RECONVENED MEETING OF LOCAL REVIEW BODY

3. CONSIDER NOTICE OF REVIEW REQUEST: LAND NORTH EAST OF ARIVORE FARM, WHITEHOUSE, TARBERT, ARGYLL, PA29 6XR (REF: 14/0002/LRB)

**ERECTION OF 1 X WIND TURBINE (34.5M TO BLADE
TIP) WITH ASSOCIATED ELECTRICAL CABINET
AND FORMATION OF ACCESS TRACK**

**PLANNING REFUSAL REFERENCE NUMBER
13/02164/PP**

VIEW 3 - wireframe

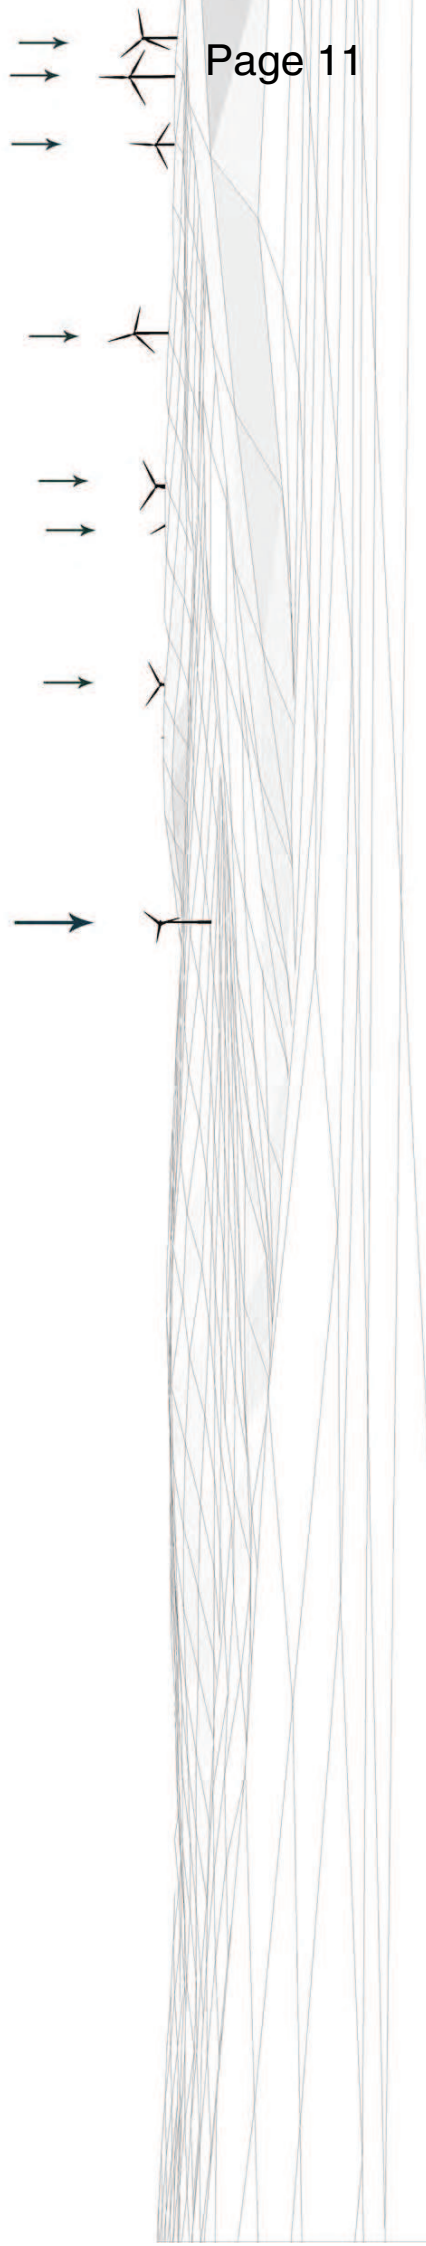
Attached is a wireframe image the appellant provided during the determination of the application. Views 3 and 4 demonstrate this unfortunate relationship to an extent; however different viewpoint locations would have been selected for a more thorough cumulative assessment than that provided by the applicant had the appeal decision been available at that time.
